GENOA APODMENTS

2000 23RD AVE S | SEATTLE, WA 98144
3032048-EG

EARLY DESIGN GUIDANCE MEETING 2

MEETING DATE:
November 1, 2018 6:30pm

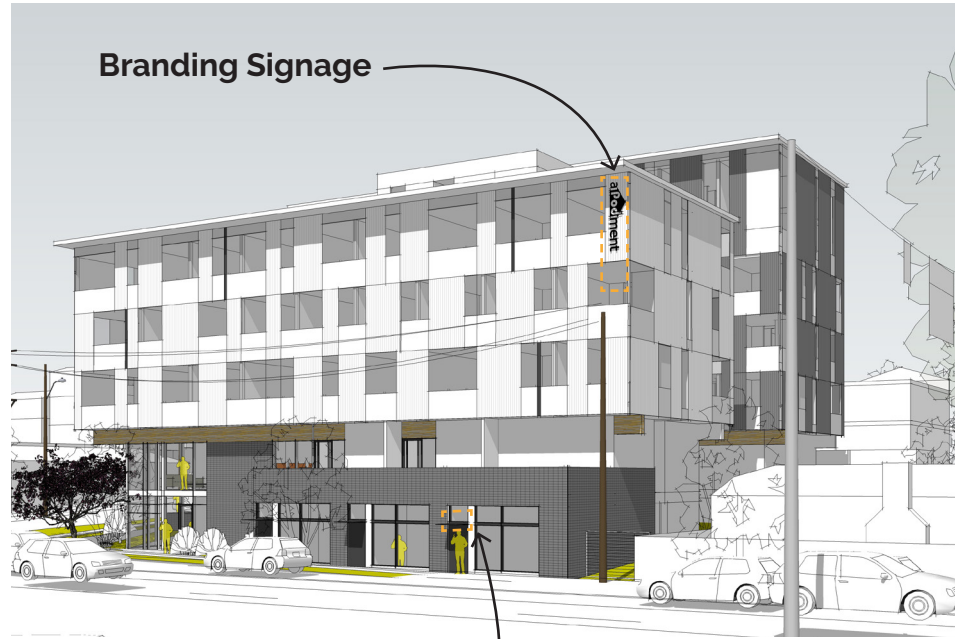
EDG Comment: 6. Signage:

The Board was concerned about the building signage and the lack of customization to the neighborhood and stressed that building signage should create a unique sense of identity for the building residents. The building expression through its signage to be of the neighborhood was of special importance because of the sites' gateway location.

RESPONSE:

Building identity emphasized through the use of large scale graphic motif visible from both Plum and 23rd Ave. Brand graphic signage will be located on the North and West facades facing the traffic along 23rd Ave S, Rainier Ave and the Plum St and building specific signage located at residential Entries on 23rd and Plum. Live-Work signage located adjacent to each Live-Work.
